Wearplate, RH Fwd

DART AEROSPACE LTD	Work Order: 62346
Description: LAFAL DLATE	Part Number: D4132 - 042
Inspection Dwg: D 4(32-2) Rev: pb2	Page 1 of 1

W/O: 6	2346	WORK ORDER C	HANGES				
DATE	STEP	PROCEDURE CHANGE	Ву	Date	Qty	Approval Chief Eng / Prod Mgr	Approval QC Inspector
101979	110	Acceptable to D4132 RenA REF ATTACHED EMAIL.	P	14.09,29		10.09.29

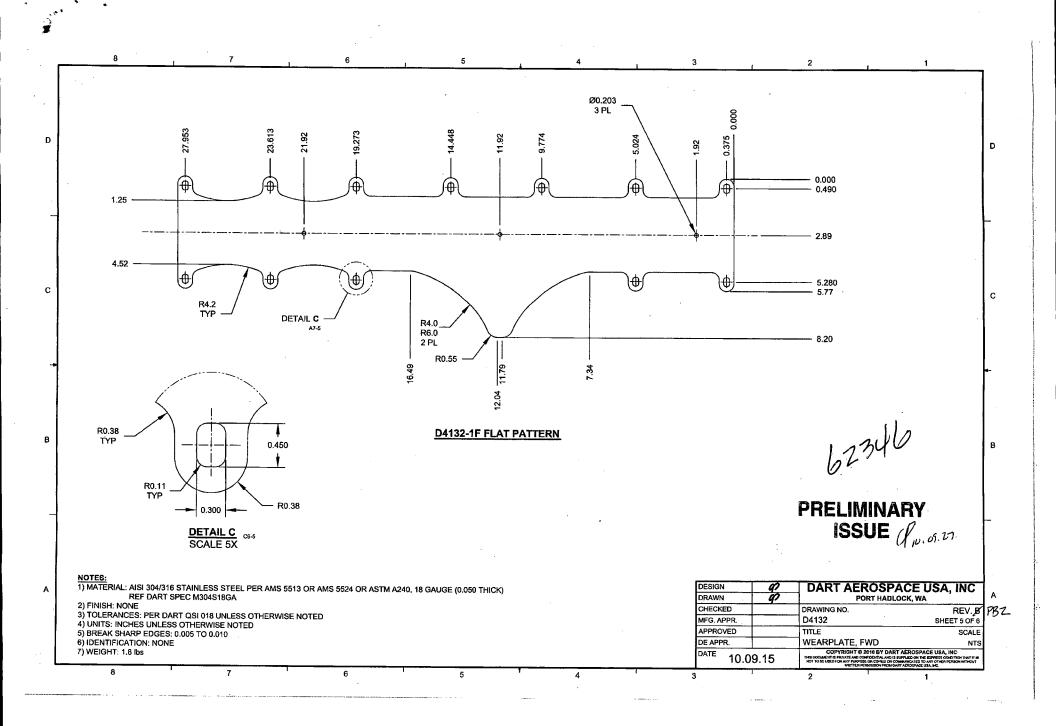
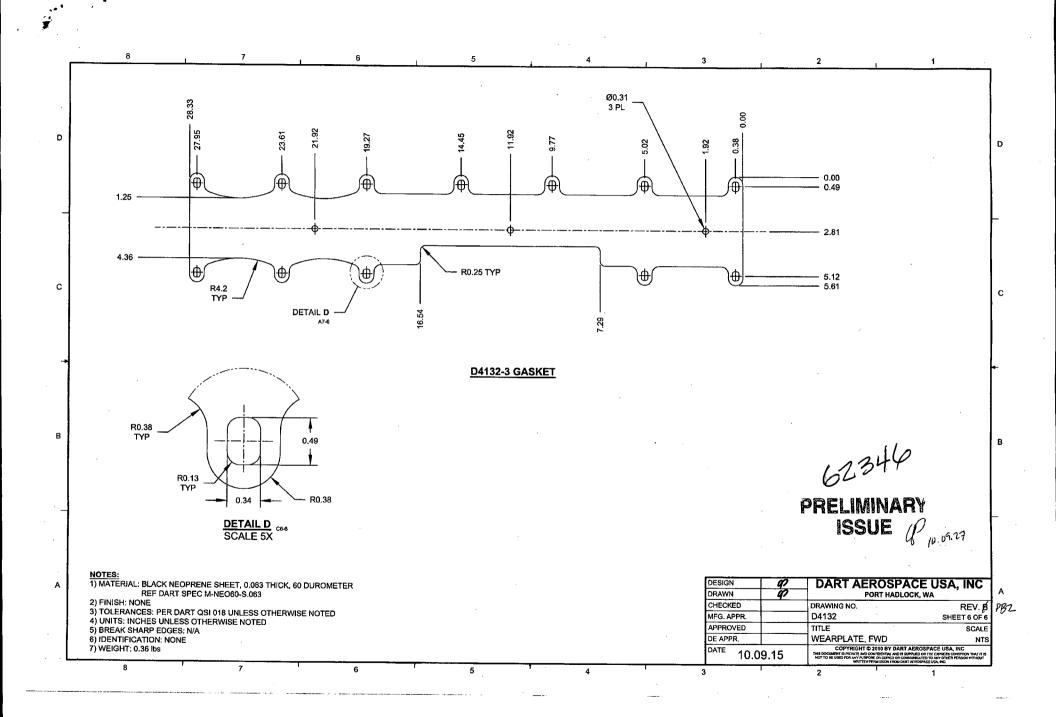
I am signing off the wearplates based on Rev. A of the dwgs, with the deviation that the wearplates are 0.150 wider. Additionally, on the fwd wearplate, one tab is shifted 0.050" aft, and another tab is shifted .150" aft. This is a minor, non-structural, change to improve fit on the skidtube.

No ... ship the wearplates.
